Petition Number: 2023-039

From: Jake Carpenter, PE Reviewer: Natalie King, PE

Date	Description		
7-26-23	First Review (IW)		
11-27-23	Second Review (DR)		
2-21-24	Third Review (NK)

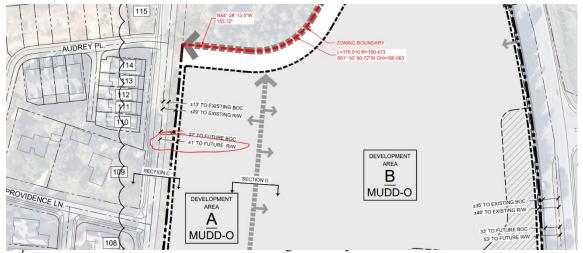
Additionally, this petition is coordinating to study the roadway network in conjunction with other ongoing projects in the immediate area. The overall study may have impacts on the improvements this project may be required to do.

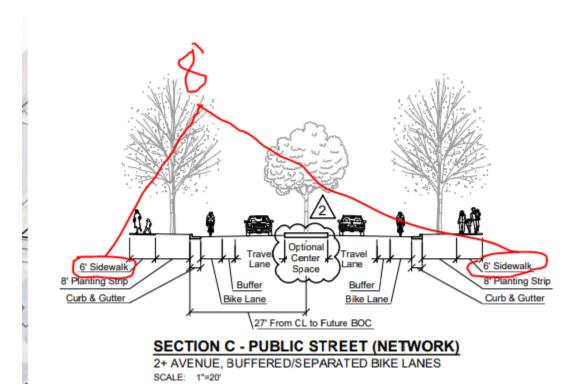
New Comment 11.27.23: Section C public street network sidewalk width does not match the conditional note. Revise Section C to have an 8' sidewalk like the conditional notes for the Old Providence Road section.
